**Bridge Road and Victoria Street Activity Centres
Draft Amendment C291yara**

Yarra Activity Centres Standing Advisory Committee Report 3

24 June 2022

Figure 2 Exhibited Interfaces H and post-exhibited Interface J

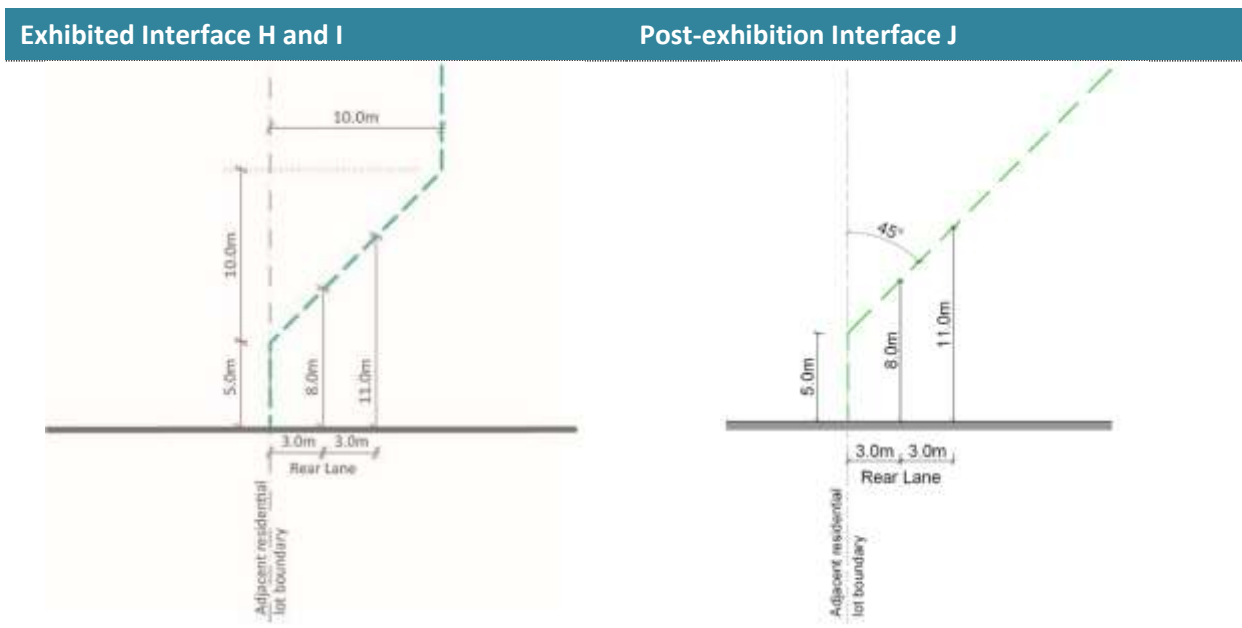
Council advised that, since exhibiting the Amendment, it notified affected people of a new Interface J, as shown in Figure 2 of this report. Prof McGauran explained:

Figure 4 DDO41 Proposed change to Height and Interface Plan for 146 and 148 Bridge Road, Richmond (PMTV Australia Pty Ltd & Keramitsis)

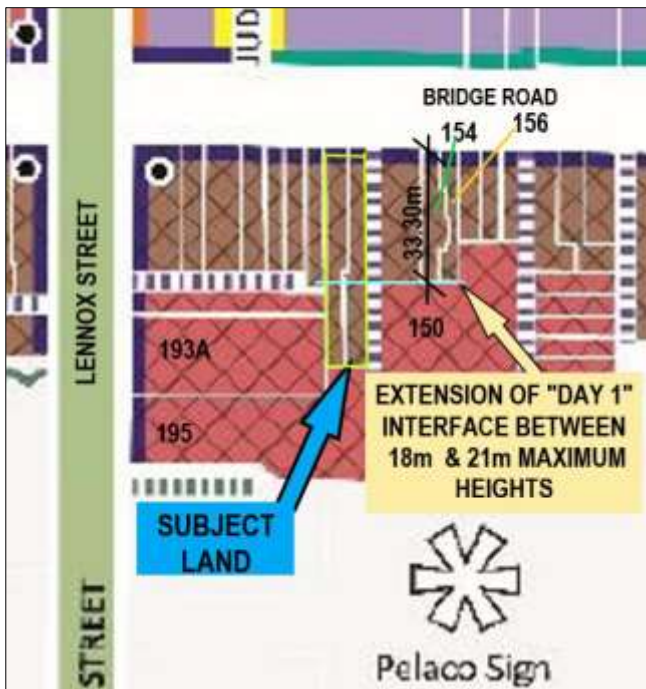
PMTV Australia Pty Ltd and A and C Keramitsis (PMTV) submitted that the rear (south) section of 146 and 148 Bridge Road, Richmond should have a 21 metre mandatory maximum building height, rather than 18 metres as exhibited. They sought to change the DDO41 Plan 1 Height and Interface Plan to show a matching alignment with 150 Bridge Road, Richmond in relation to the height designations. This is shown on Figure 4 below.

PMTV submitted that the extensive depth of lots allowed for generous setbacks and therefore higher built form to the rear without creating visual impacts on the Bridge Road streetscape. PMTV submitted that property boundaries were not permanently fixed and shouldn't in all cases be the principal factor in determining building height provisions. They referred to a current plan of subdivision which had been prepared to subdivide the rear portion of these properties and create a separate parcel with extensive frontage to Wustemenn Place.

The Committee supports a change to the DDO41 Height and Interface Plan to apply a 21 metre mandatory maximum building height to the rear of 146 and 148 Bridge Road as shown in Figure 4. The depth of these lots allow for a higher built form to the rear that would not negatively impact on the heritage streetscape and street wall along Bridge Road and would be consistent with higher built form permitted on either side of these properties. The Committee agrees that property boundaries should not be the sole determinant of proposed maximum building height provisions. In this case, that it is appropriate to have a different height at the front of the site to the rear of the site, and that site context and consideration of the DDO41 objectives are significant factors influencing the application of provisions.

Figure 5 DDO41 Proposed changes to Height and Interface Plan for land in Allowah Terrace and at 193 and 193a Lennox Street (G Kyriakopoulos)

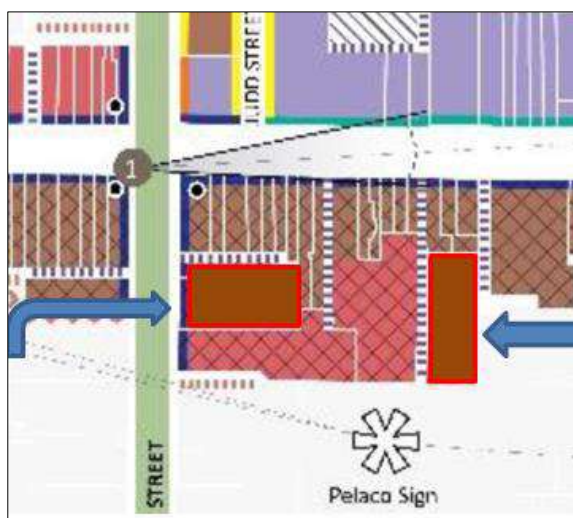
Ms Kyriakopoulos submitted that a mandatory maximum building height of 18 metres, or preferably 16.5 metres, would be appropriate for 193 and 193a Lennox Street, Richmond to protect the heritage character of the Richmond Hill Precinct and to reduce potential impacts on views to the Pelaco building and sign.

Figure 12 DDO48 Plan 2 (Access and movement plan)

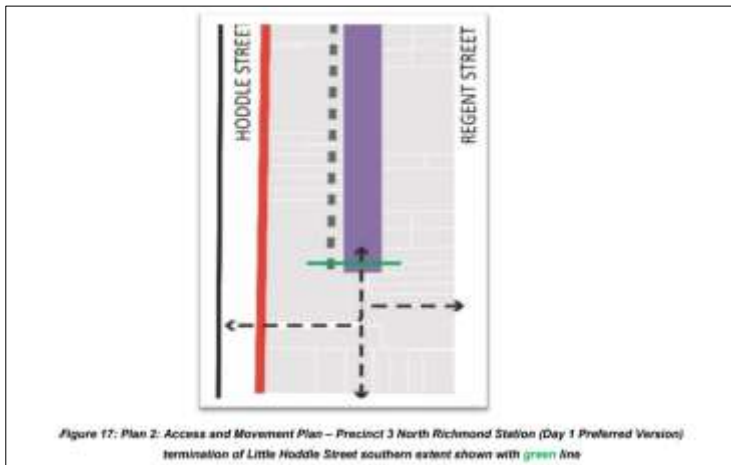
Beresford submitted that DDO48 Plan 2 (Access and movement plan) included an error because the graphics depicting 'Potential Future Shared Zones' extend past the southern end of Little Hoddle Street into Beresford's private property by approximately 4.7 metres. Beresford said:

The 'Plan 2: Access and Movement Plan' must be amended to reflect the termination of the southern end of Little Hoddle Street at the property boundary of the Beresford Land as shown with a green line in Figure 17. It is inappropriate to extend a potential future shared zone into private property.

Design and Development Overlay Schedule 48 Plan 2 (Access and movement plan) should be amended to terminate the southern end of Little Hoddle Street at the property boundary of 67-81 Hoddle Street and 84 Regent Street, Richmond.

- e) **correct Plan 2 (Access and movement plan) to terminate the southern end of Little Hoddle Street at the property boundary of 67-81 Hoddle Street and 84 Regent Street, Richmond.**

Council agreed that DDO48 Plan 2 (Access and movement plan) included an error and required correction.

Plan 1: Height and Interface Plan – Precinct 1 Bridge Road West

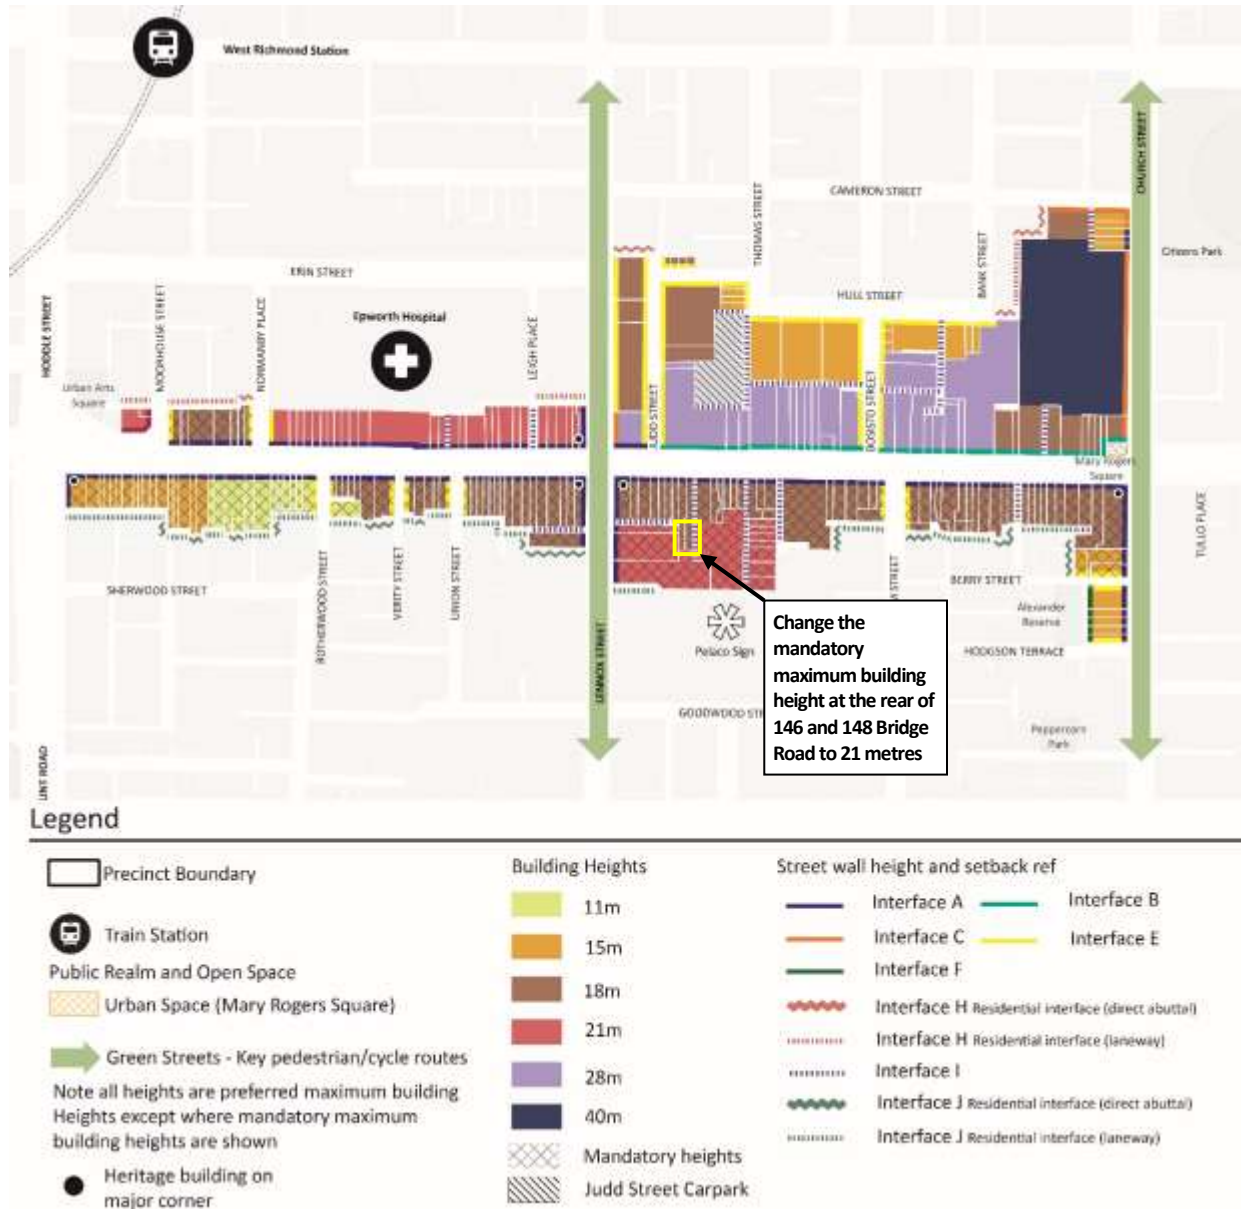
Delete Plan 1 (Height and interface plan) and replace with below

- b) change the mandatory maximum building height across the rear of 146 and 148 Bridge Road, Richmond
 - c) clarify mapping of Interface J near 242 Bridge Road, Richmond

Plan 2: Access and Movement Plan – Precinct 4 Bridge Road East South

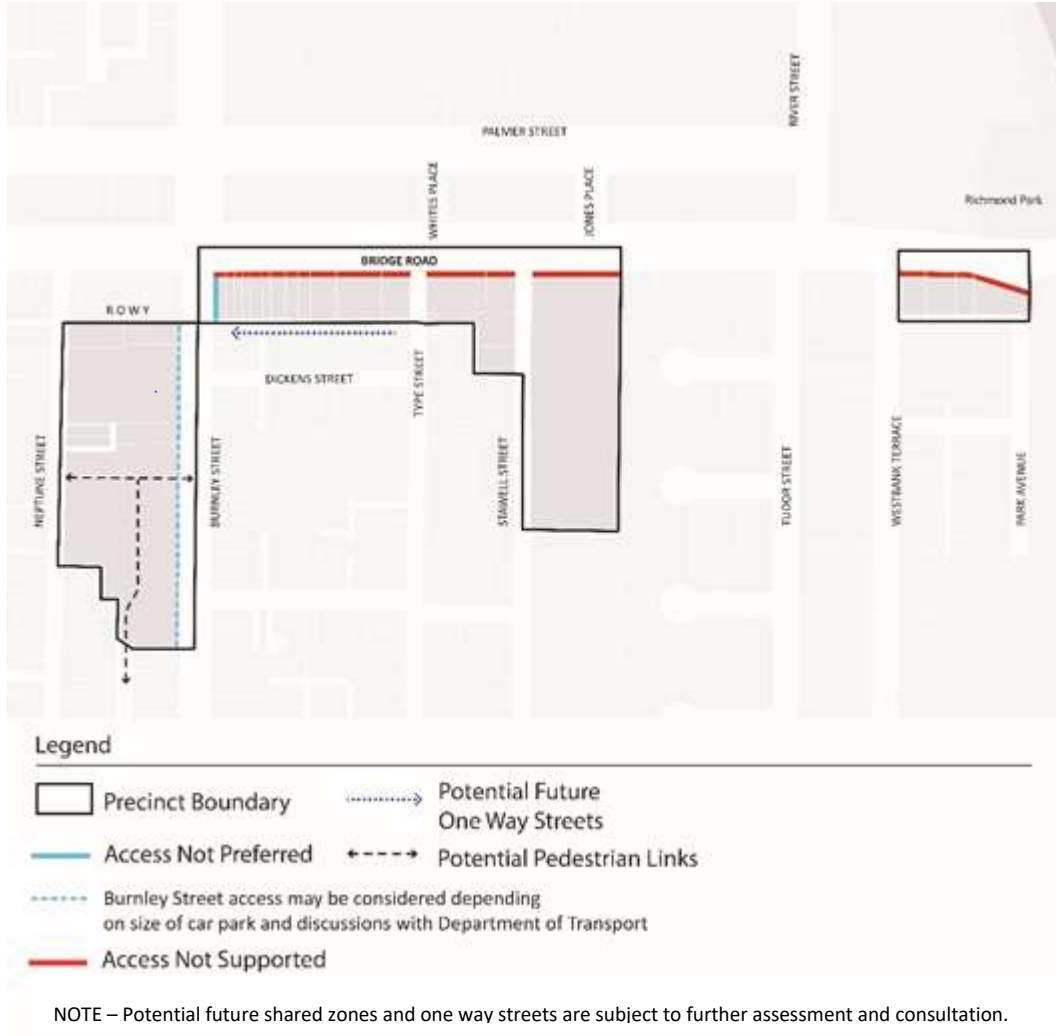
Delete and replace Plan 2: Access and Movement Plan

The potential pedestrian link through 566 Bridge Road as shown on Plan 2 (Access and movement) in Design and Development Overlay Schedule 44 should be removed because it would not allow for the creation of a public thoroughfare.

- d) **remove the potential pedestrian link from 566 Bridge Road, Richmond.**

Figure 1 to Schedule 44 – Interface J – to residential properties in NRZ or GRZ

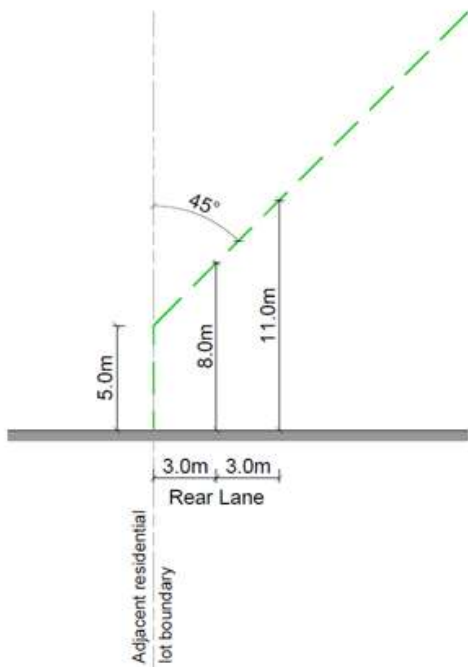
Delete Figure 1 (Interface H) and replace with below

Plan 1: Height and Interface Plan – Precinct 3 North Richmond Station

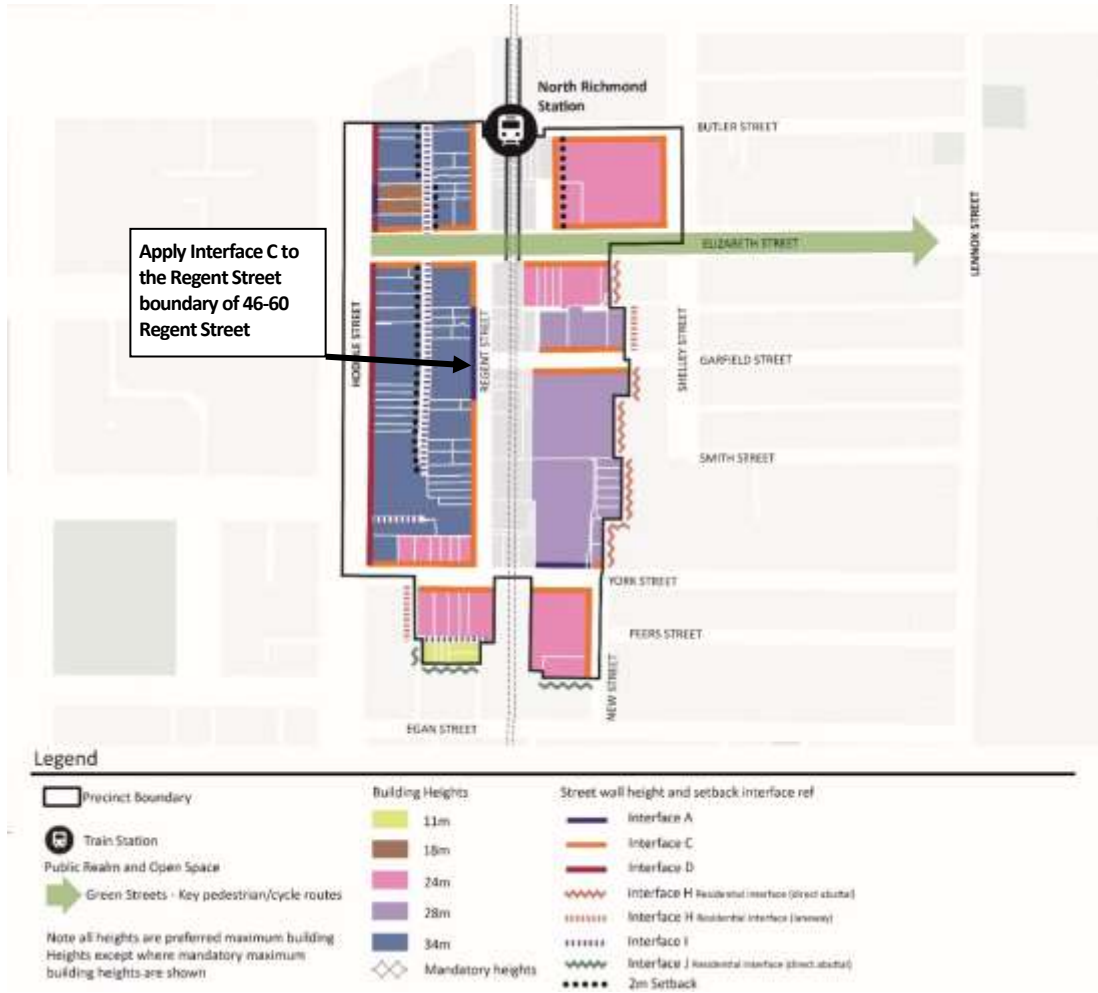
Delete Plan 1 (Height and interface plan) and replace with below

Plan 2: Access and Movement Plan

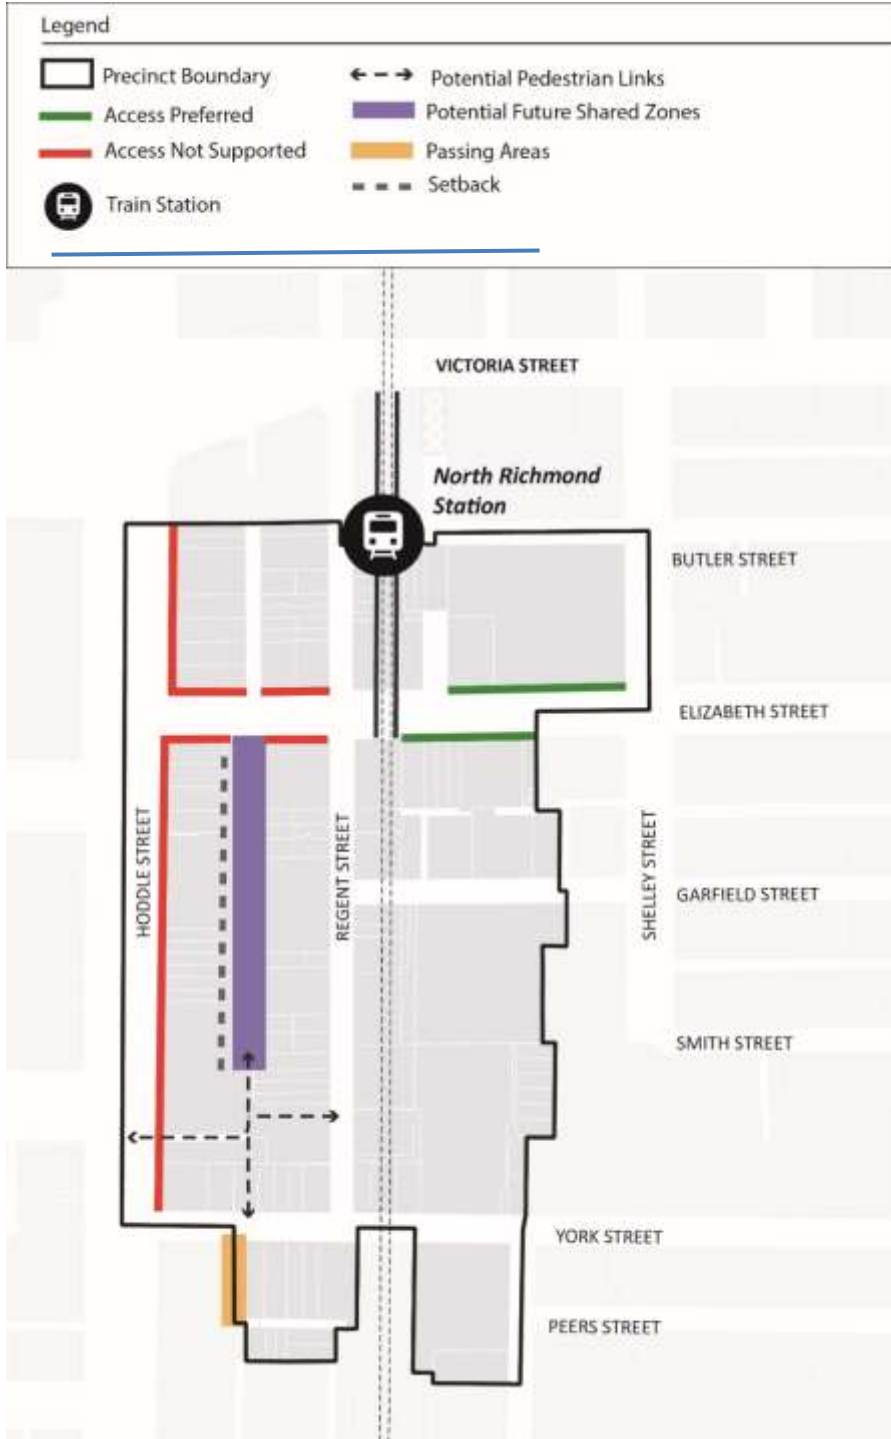
Delete Plan 2 (Access and movement plan) and replace with below

Plan 1: Height and Interface Plan – Precinct 4 Victoria Street East

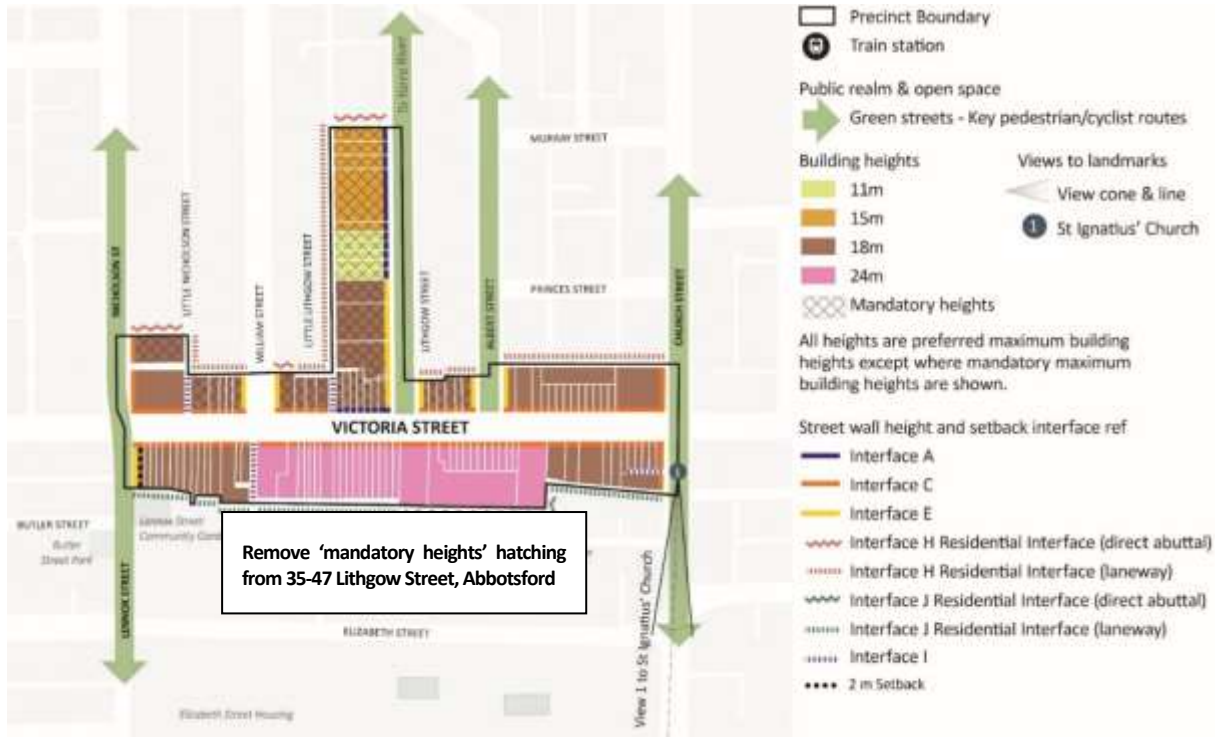
Delete Plan 1 (Height and interface plan) and replace with below

- 14. Amend Design and Development Overlay Schedule 49, as shown in Appendix F4, to change the mandatory maximum height for 35-47 Lithgow Street, Abbotsford to a discretionary height provision.**

Plan 2: Access and Movement Plan – Precinct 4 Victoria Street East

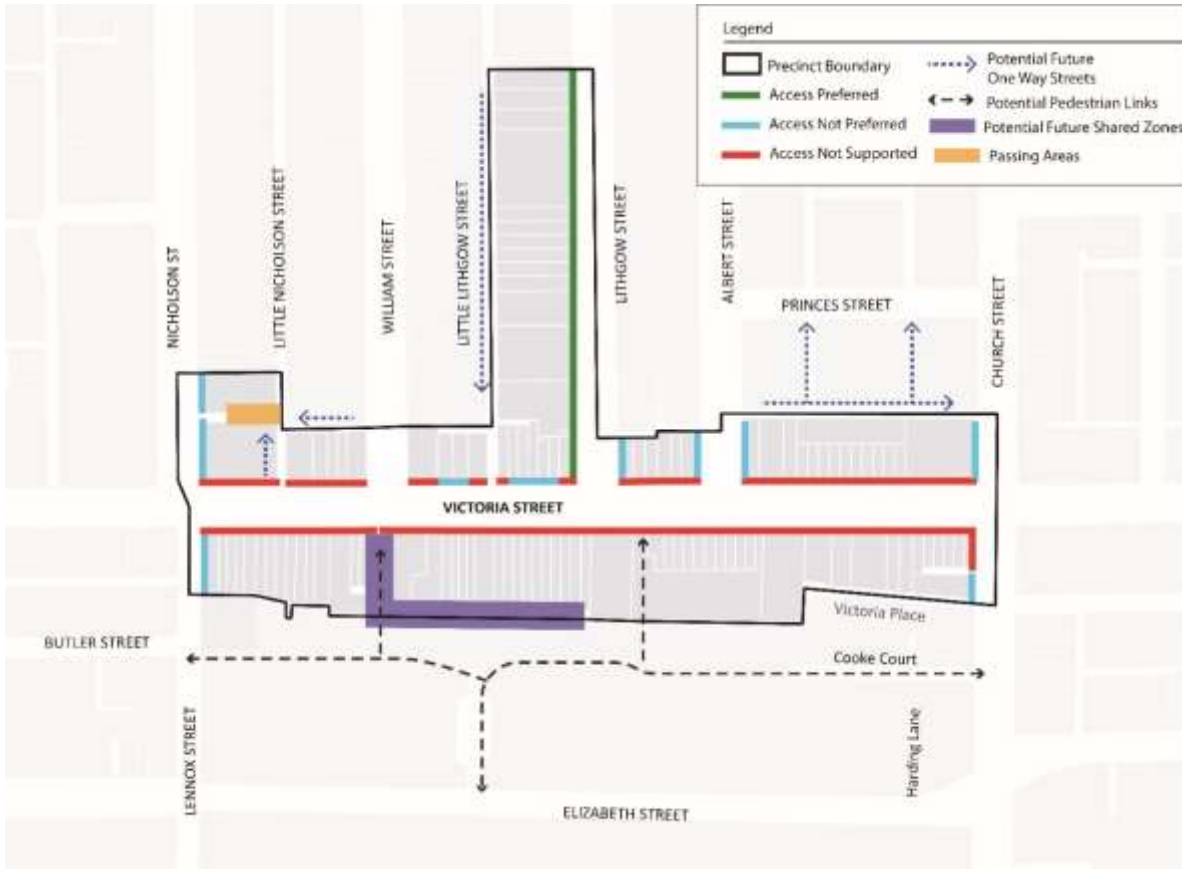
Delete Plan 2 (Access and movement plan) and replace with below
